Access Compliance Report

Public Rights-of-Way

(Pedestrian Signals)

Intersection ID: N/A	Main Street:	Cross Street: N/A	Location: N/A
ADA ID: 7707290BCD9D	Signal Type: Two Push Buttons-Non APS	Overall Compliance: No	Severity Score: BTN 1:N/A BTN 2: N/A No BTN: N/A
Codes/Mitigation Info/Possible Solution		Field Measurements/Component Compliance

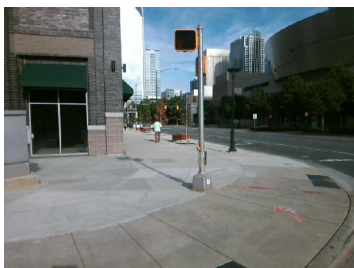
PROW/ADA: TMUTCD 4e.08, R404.2, R404.3, R406.2

Compliance	Description	Data	Compliance	Description	Data
	Button Count	Button2	N/A	Distant to Additional Button (in)	N/A
	Additional Button Present?	N/A		Additional Button ID	N/A
N/A	Signal Buttons Required?	N/A	N/A	Additional Ped Posts Required	N/A
	How Many Ped Street Xings?	2		Located In An Island/Median?	No
N/A	B 1 Sign Present?	Yes	N/A	B 2 Sign Present?	Yes
Yes	B 1 Sign Purpose?	Yes	Yes	B 2 Sign Purpose?	Yes
Yes	B 1 Sign Lettering & Contrast?	Yes	Yes	B 2 Sign Lettering & Contrast?	Yes
Yes	B 1 Parallel To XWalk?	Yes	Yes	B 2 Parallel To XWalk?	Yes
Yes	B 1 PAR to Button?	Yes	Yes	B 2 PAR to Button?	Yes
Yes	B 1 PAR to XWalk?	Yes	Yes	B 2 PAR to XWalk?	Yes
Yes	B 1 Clear Floor Space?	Yes	Yes	B 2 Clear Floor Space?	Yes
N/A	B 1 FWD Approach?	Yes	N/A	B 2 FWD Approach?	Yes
N/A	B 1 FWD Approach Constrained?	No	N/A	B 2 FWD Approach Constrained?	No
No	B 1 FWD Approach Reach (in)	3.0	No	B 2 FWD Approach Reach (in)	4.0

N/A	B 1 FWD Approach Width (in)	N/A	N/A	B 2 FWD Approach Width (in)	N/A
N/A	B 1 FWD Approach Obstruction?	Yes	N/A	B 2 FWD Approach Obstruction?	Yes
N/A	B 1 FWD Approach Obstruction Dist (in)	3.0	N/A	B 2 FWD Approach ObstructionDist (in)	4.0
N/A	B 1 PARA Approach?	Yes	N/A	B 2 PARA Approach?	Yes
N/A	B 1 PARA Approach Constrained?	No	N/A	B 2 PARA Approach Constrained?	No
Yes	B 1 PARA Approach Reach (in)	3.0	Yes	B 2 PARA Approach Reach (in)	4.0
N/A	B 1 PARA Approach Width (in)	N/A	N/A	B 2 PARA Approach Width (in)	N/A
N/A	B 1 PARA Approach Obstruction?	Yes	N/A	B 2 PARA Approach Obstruction?	Yes
N/A	B 1 PARA Approach Obstruction Dist (in)	3.0	N/A	B 2 PARA Approach ObstructionDist (in)	4.0
No	B 1 Clear Floor Space Slope (%)	3.8	No	B 2 Clear Floor Space Slope (%)	3.4
No	B 1 Clear Floor Space XSlope (%)	2.5	No	B 2 Clear Floor Space XSlope (%)	5.0
N/A	B 1 PAR Slope (%)	2.1	N/A	B 2 PAR Slope (%)	1.6
Yes	B 1 Height (in)	35.0	Yes	B 2 Height (in)	36.5

Yes	B 1 Clear Xing Direction?	ClearlyMarked	Yes	B 2 Clear Xing Direction?	ClearlyMarked
	B 1 Crossing Direction	To SE		B 2 Crossing Direction	To NE
Yes	B 1 DistanceTo XWalk (in)	0.0	Yes	B 2 DistanceTo XWalk (in)	0.0
No	B 1 DistanceTo Curb (in)	152.0	No	B 2 DistanceTo Curb (in)	135.0
Yes	B 1 Diameter (in)	2.0	Yes	B 2 Diameter (in)	2.0

Possible Solutions: Replace Signal Push Button With APS Button on New Post. Remove & Relocate Sign.
